PIC16F505 Rev. A Silicon/Data Sheet Errata

The PIC16F505 parts you have received conform functionally to the Device Data Sheet (DS41236D), except for the anomalies described below.

FIGURE 1: DEVICE CURRENT WHEN ENTERING SLEEP

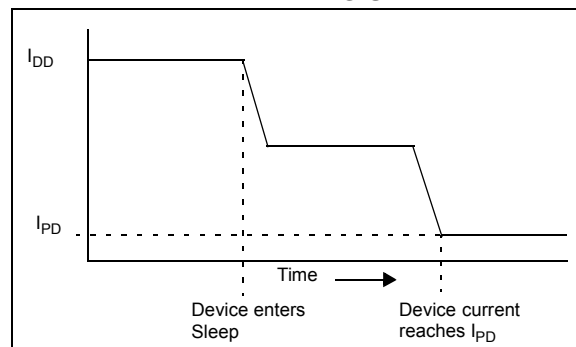
On the PIC16F505 silicon, revisions earlier than A3, the power-down base current may remain higher than the specification for a short time when entering Sleep.

Figure 1 illustrates the device current upon entering Sleep.

The length of time between the device entering Sleep mode and the device current reaching I_{PD} increases as both temperature and voltage decrease.

This issue is fixed in Revisions A3 and later.
